From: Anchondo, Isaac
To: [Collins, Jay](#)
Cc: [Werner, Greg](#); [Proulx, David](#); [Kopriva, Ron](#); [Alley, David](#)
Subject: Leak Location
Date: Thursday, October 13, 2016 1:39:00 PM
Attachments: [leak location.pdf](#)

4. Reason for Request

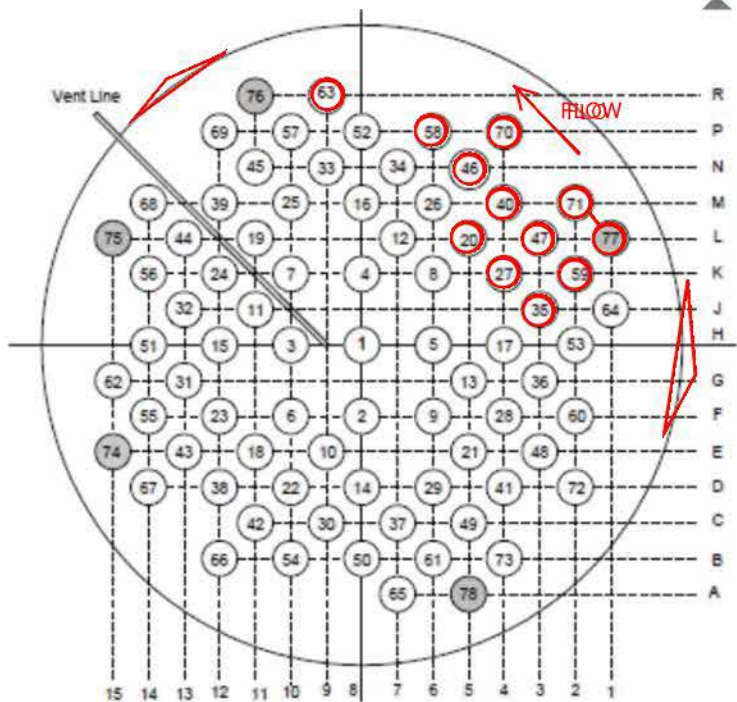
I made an attempt to identify the location of the nozzles to be inspected from some of the pictures that Ron took this past Saturday. Unfortunately, it's hard to see the vicinity of some of the nozzles that you question during the call (i.e., 52, 34, 26).

One item of note, the view next to the vent line is a bit confusing where it's hard to figure out which side you are looking at in relation to the drawing provided.

INSERT FIGURE SHOWING PENETRATION LOCATIONS

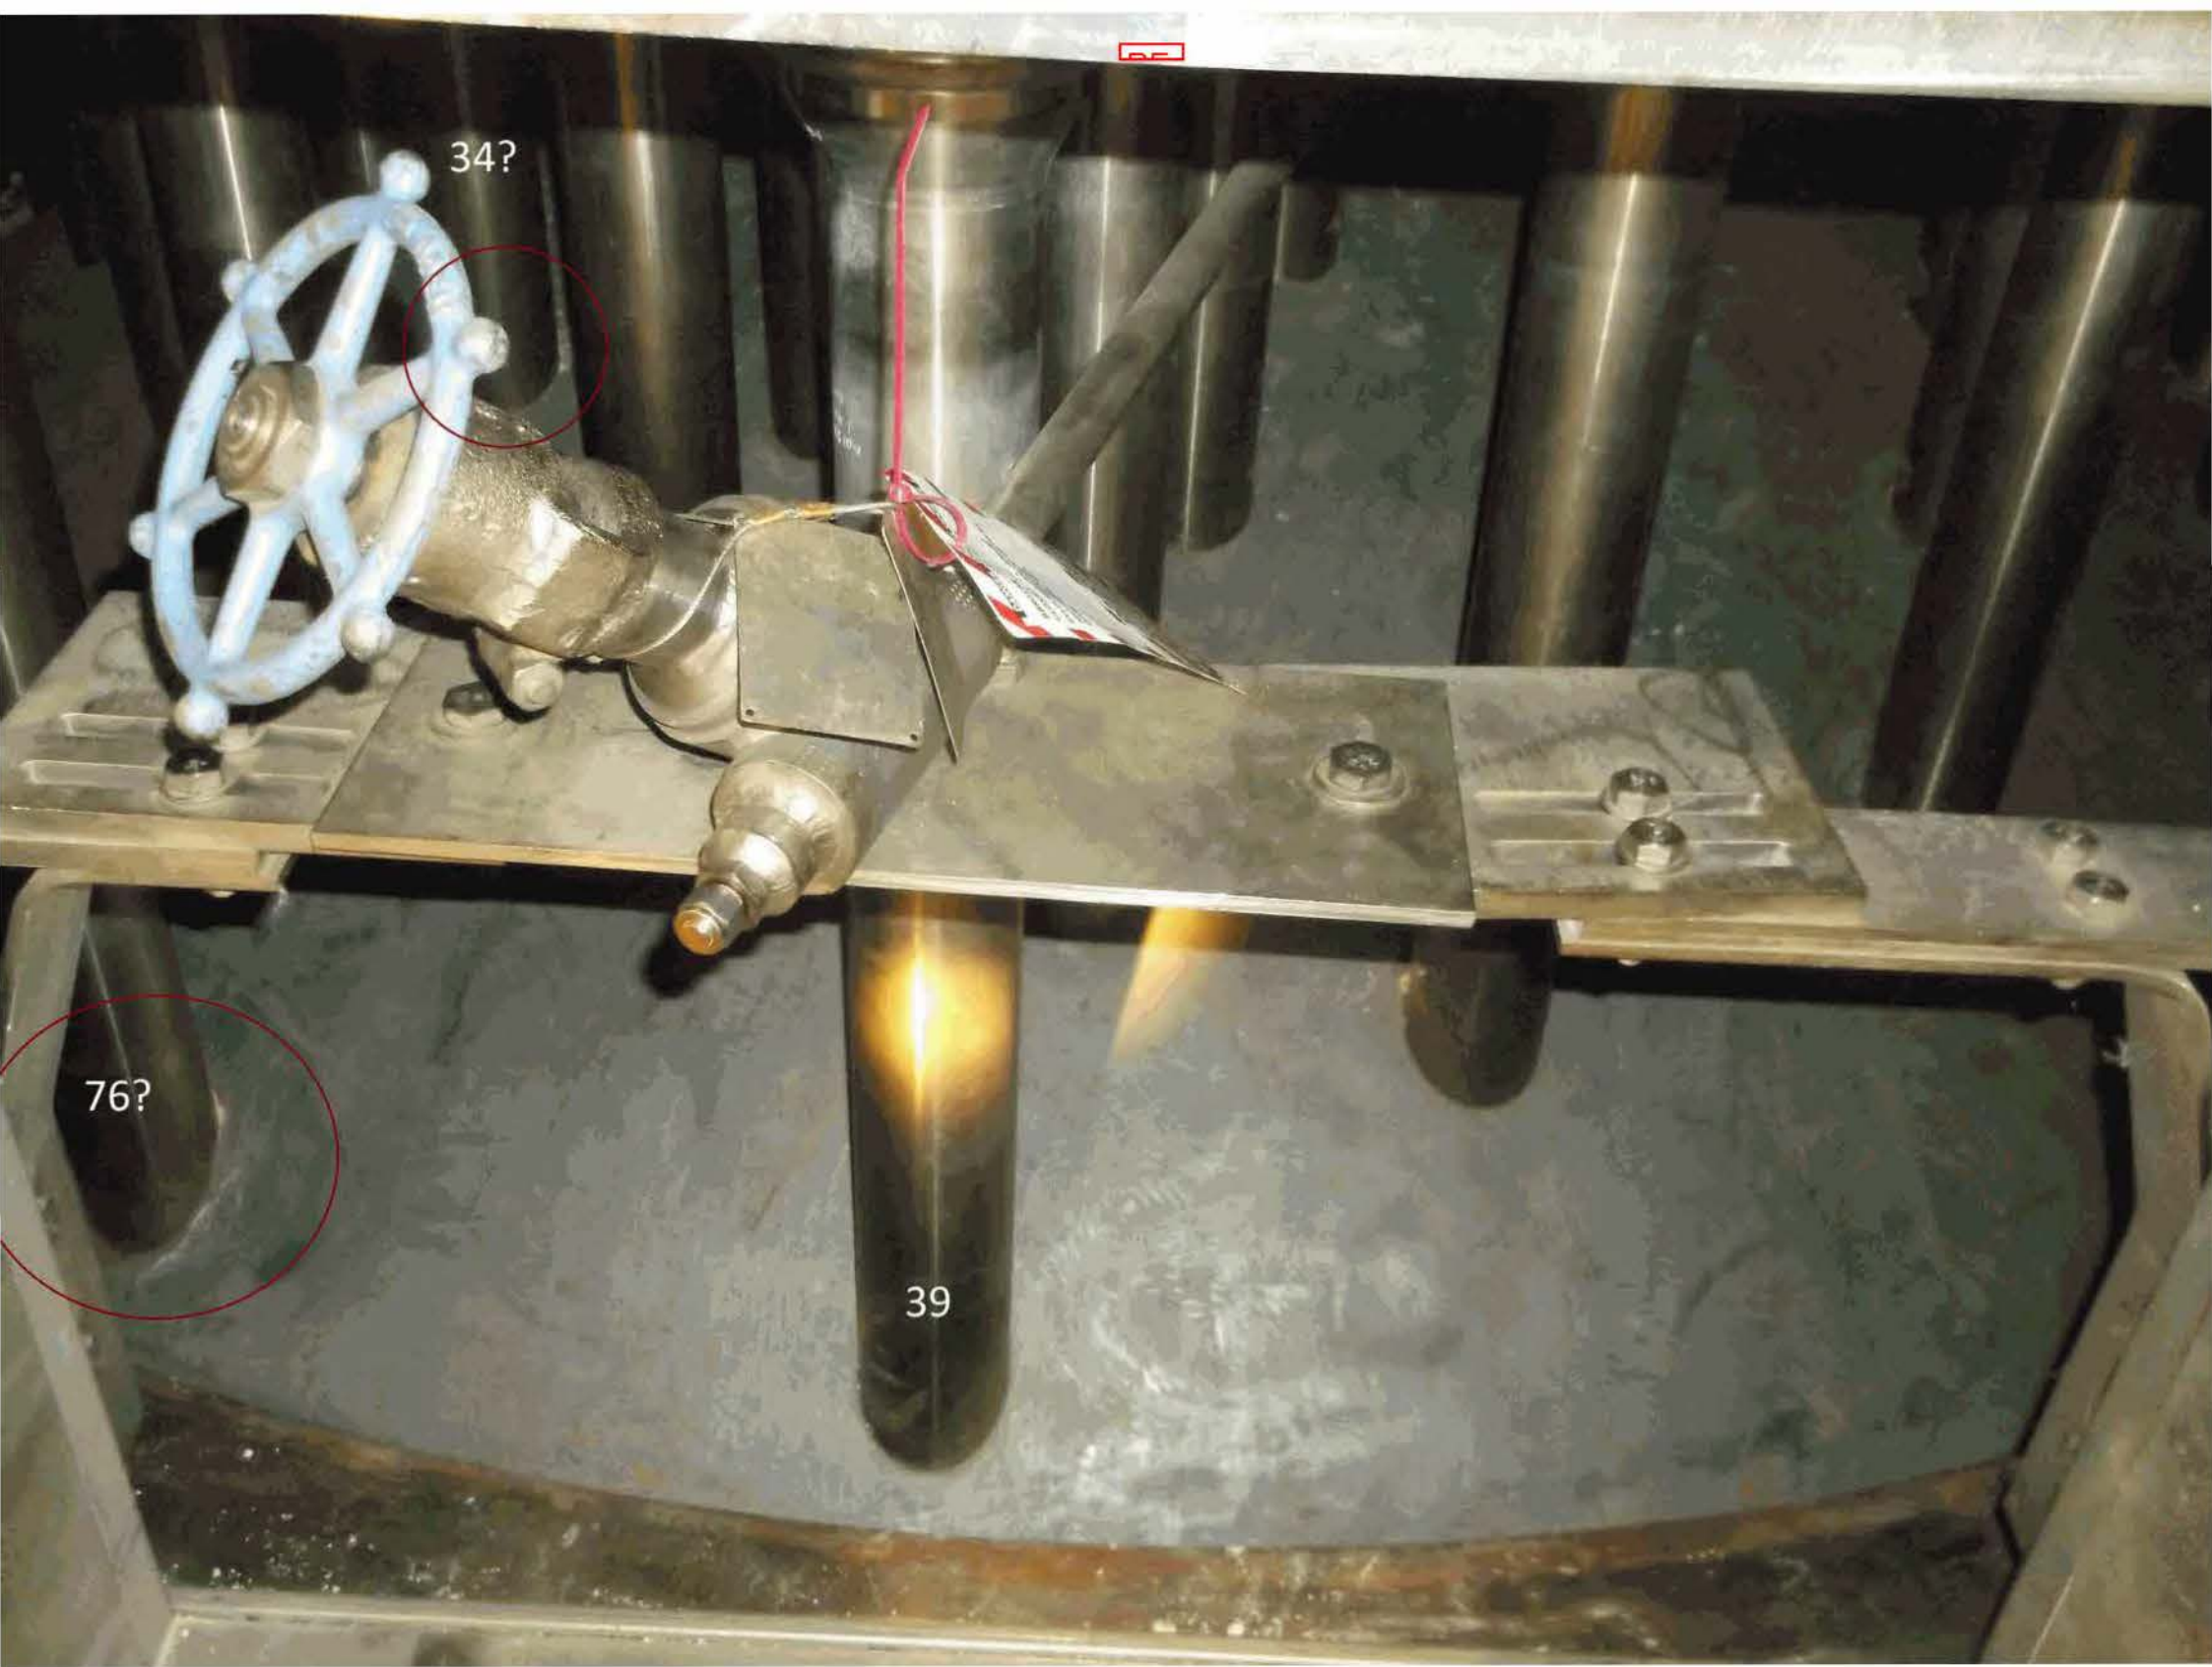
Based on visual examination (VE), deposits resulting from leakage in the canopy seal weld on penetration 77 are on the Reactor Vessel Closure Head. These deposits are dispersed on the reactor head in such a way that it is evident they resulted from the spray pattern, or spray deflection, from the canopy seal weld leak. Other observations noted were: 1) the condition of the head which only had surface rust present rather than wastage; 2) the color and location of these deposits were consistent with spray following the crud burst that was then oxidized by exposure to the atmosphere; 3) there was a layer of white boric acid on top of the deposits in a similar pattern indicating that clean borated water had followed the same path; and 4) no penetrations other than those in the path of the spray/deflection show any abnormal indications.

With this evidence indicating the condition resulted from the canopy seal weld leak above the head the deposits still obscure the head and prevent the required VE from being performed on the affected penetrations. WCNOG will perform supplemental examinations of the affected penetrations.

Twelve penetrations require supplemental examination in accordance with code requirements. Per paragraph -3200(b) of N-729-1 these supplemental examinations "...shall include volumetric examination of the nozzle tube and surface examination of the partial-penetration weld,...".
